Access Compliance Report

Public Rights-of-Way

(Curb Ramps)

Intersection ID: 48198	Main Street: RIVERGATE_PY	Cross Street: S_TRYON_ST	Location: SE
ADA ID: F690D4141D60	Ramp Type: Perp	Initial Pass/Fail: Fail	Overall Compliance: No
Severity Score: 8.75			
Codes/Mitigation Info/Possible Solution		Field Measurements/Component Compliance

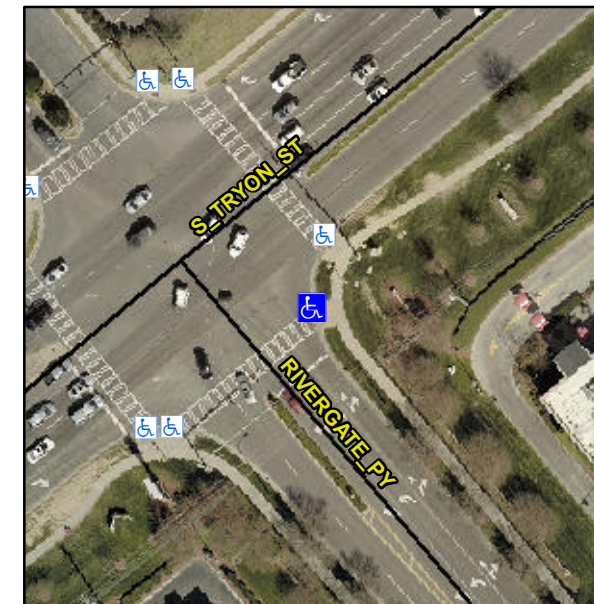
PROW/ADA:

Not Found, R304.5.1

Compliance	Description	Data	Compliance	Description	Data
N/A	Ramp Length (in)	98.0	Yes	Ramp Slope (%)	6.5
No	Ramp Width (in)	37.0	Yes	Ramp XSlope (%)	0.5
N/A	Flare Type LT	N/A	N/A	Flare Type RT	N/A
N/A	Flare Slope LT (%)	N/A	N/A	Flare Slope RT (%)	N/A
N/A	Flare Traversable LT?	N/A	N/A	Flare Traversable RT?	N/A
N/A	Landing Length (in)	N/A	N/A	DWS Provided?	N/A
N/A	Landing Width (in)	N/A	N/A	DWS Contrast?	N/A
N/A	Landing Slope (%)	N/A	N/A	DWS Length (in)	N/A
N/A	Landing X Slope (%)	N/A	N/A	DWS Full Width?	N/A
N/A	Landing Curb? (Y/N)	N/A	N/A	DWS Offset (in)	N/A
N/A	Shared Landing?	N/A			
N/A	Gutter Ponding?	N/A	N/A	Gutter Slope (%)	N/A
N/A	Gutter Lip Ht (in)	N/A	N/A	Gutter X Slope (%)	N/A
N/A	Painted X Walk1?	Yes	N/A	Painted X Walk2?	N/A
	X Walk 1 Direction	To W		X Walk 2 Direction	N/A
N/A	X Walk 1 Width (in)	113.0	N/A	X Walk 2 Width (in)	N/A
	X Walk 1 Slope (%)	0.1		X Walk 2 Slope (%)	N/A
	X Walk 1 X Slope (%)	0.8		X Walk 2 X Slope (%)	N/A

Possible Solutions:

Remove & Replace Entire Ramp.
